## Reviewer 1

Your paper tries to assess the sensitivity of the Fitch scheme in wake simulations by implementing it on a newly developed PBL scheme. I am certain that this manuscript is interesting and has some value but I am not sure whether in its actual state displays correctly this value, since I think the reader cannot gain much from all the numbers you reach with your simulations. So in the following, you find a list of major and minor/specific comments.

Response Figure 1. The page-long 3DPBL equations, as documented in Juliano et al (2022).

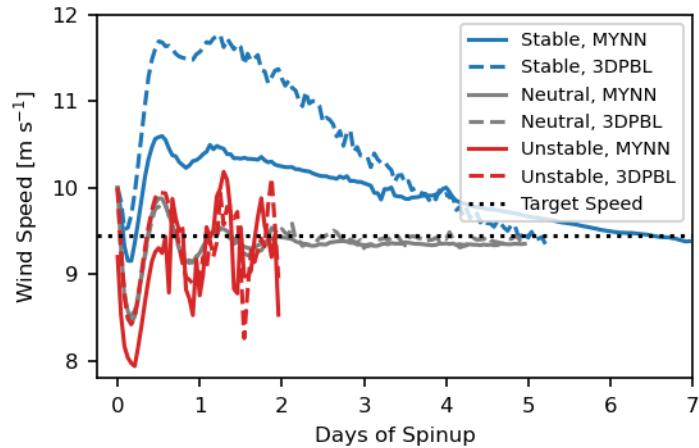
3. Second paragraph in Sect. 2.1: these lines should be complemented with the formulations so that the reader can get an idea of the advantages/extensions of the 3D TKE PBL.

Thank you for this suggestion. We wanted to do include the 3DPBL formulations in the initial draft of the manuscript, but we ultimately omitted copying the formulations from Juliano et al. (2022) to this paper, as the matrix equations in the original paper take up an entire page (Ref. Fig. 1). We include the reference to the paper with these formulations. Instead, we qualitatively and quantitatively discuss the major differences between the two PBL schemes in the manuscript (L109-133).

Response Figure 3. Figure 1 in the updated manuscript.

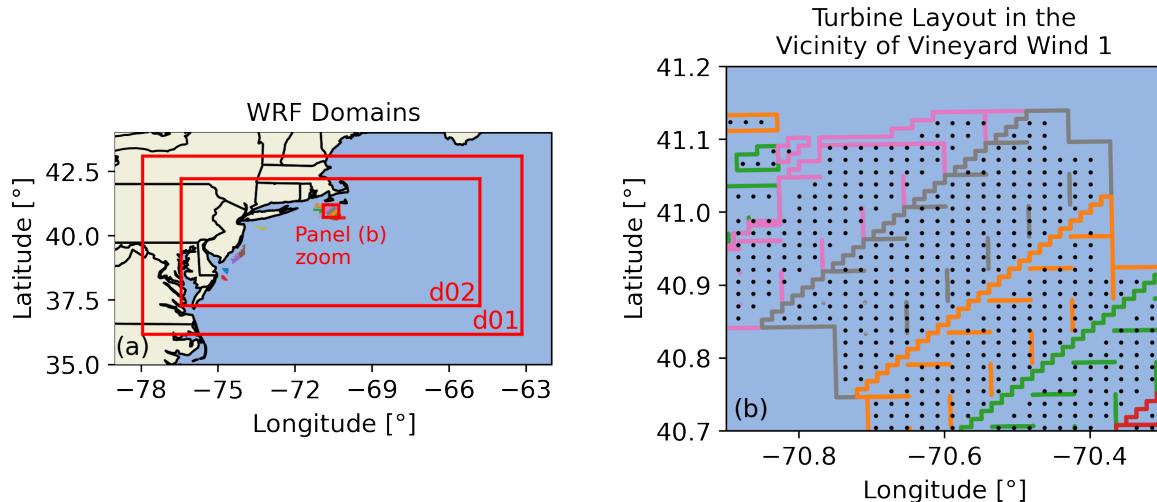
20. Figure 1. This figure can be changed to show the model domains and maybe an inset with a zoom of the vineyard wind 1 with the turbine arrangement would be nice

We have updated Figure 1 to show the model domains as well as a zoom in of Vineyard Wind 1. We have attached the updated figure below for convenience.

Response Figure 1. A TKE side view of idealized neutral simulations for which TKE advection is turned on (a) and turned off (b).

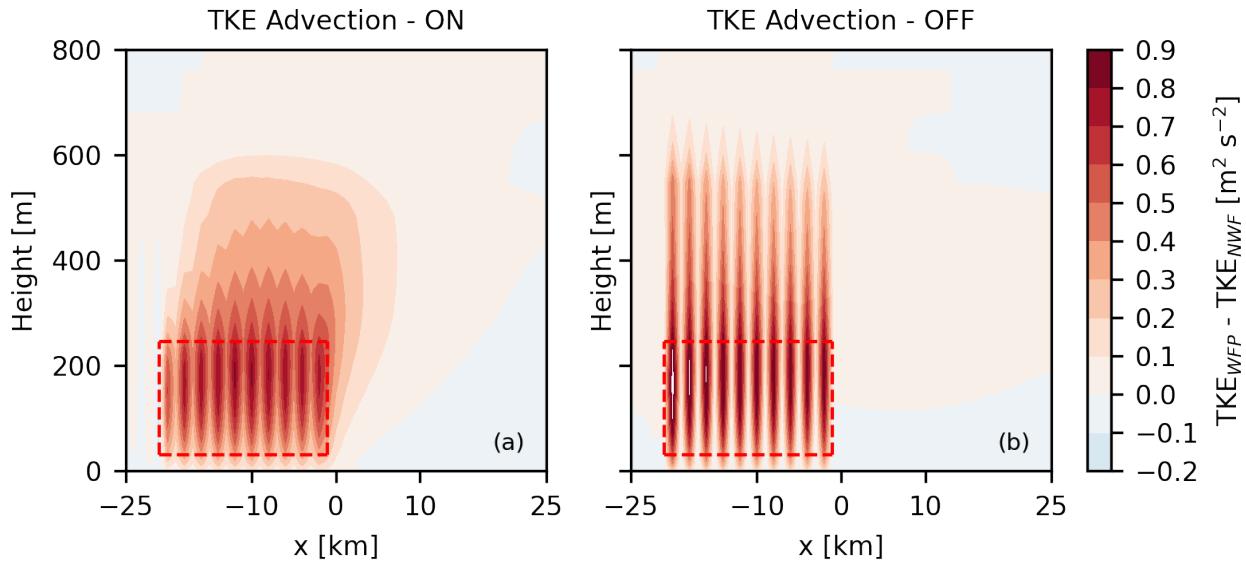
2. The authors state that TKE advection is turned on (see l. 243), but it does not seem to be true. Figure 6 shows without doubt that all the added TKE is confined within the boundaries of the wind farm and above it, but not advected downwind at all. With the MYNN scheme in particular (top two rows), one can even see the individual

positions of the turbines, one every other grid cell, with the added TKE at their grid cells and above, but none in the next adjacent cells downwind. This proves that no advection is actually operating. The authors need to double check that `bl_mynn_tkeadvect` is indeed set to true in the inner domain. Since TKE advection appears to be wrongfully turned off in all the simulations, all the conclusions of the paper are potentially invalid.

We thank you for your attention to detail regarding our methodology. We have verified that `bl_mynn_tkeadvect` was indeed turned on and functional:

- Finally, to definitively illustrate that TKE advection was turned on in the simulations in the manuscript, we have run a supplemental MYNN idealized neutral simulation in which the TKE advection was turned off. Figure RF1a has TKE advection turned on, and TKE is visibly advected downwind. Figure RF1b has TKE advection turned off, and TKE remains within vertical columns.
